**Re: Brandy Hill Quarry Extension Project (SSD 5899) – Response to EPA Comments dated
14 February 2019**

Attention:	Andrew Driver	Date:	2019-06-03
Company:	Hanson Construction Materials	Pages:	1 of 29
Email:	Andrew.Driver@hanson.com.au		
From:	Steve Thomas	Document No:	29N-14-0060 -8551052-0-V1
Subject:	Brandy Hill Quarry Air Quality Addendum - Brandy Hill Quarry Expansion

Vipac Engineers and Scientists Ltd (Vipac) provides the following Addendum to the Air Quality Assessment (AQA) Report for the Brandy Hill Quarry Expansion.

Figure C-1: Comparison of Wind Roses Developed for 2013 Measurement Data at Beresfield Monitoring Station (left) and the Modelled Data for the Same Year (right)

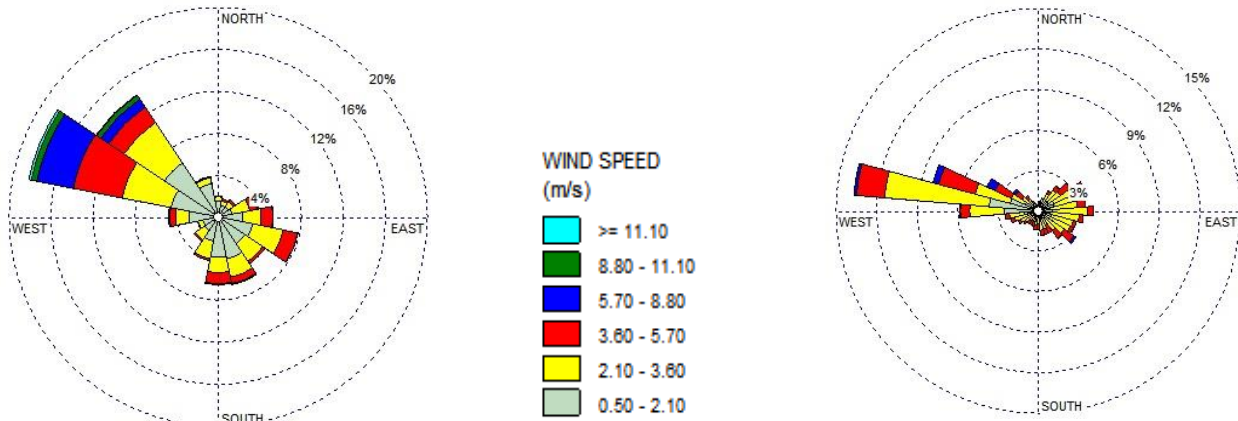
As discussed in Section 7.1 of the AQA Report, the meteorological dataset developed as input for dispersion modelling has been shown to be representative of long term local conditions at the Total BoM Station. It is correctly noted by the EPA that data from this Station was used for assimilation in the generation of the TAPM data.

Appendix C of this Addendum compares the modelled dataset with measured meteorological data at the Beresfield Monitoring Station. As discussed in Appendix C the modelled dataset is considered representative of expected conditions at the site.

Figure C-1 shows the comparison of wind roses developed for the 2013 measurement data at Beresfield Monitoring Station and the TAPM-CALMET derived data from the closest location. As shown in the figure, both wind roses feature a prevailing wind direction from the north-west with very little winds from any other direction.
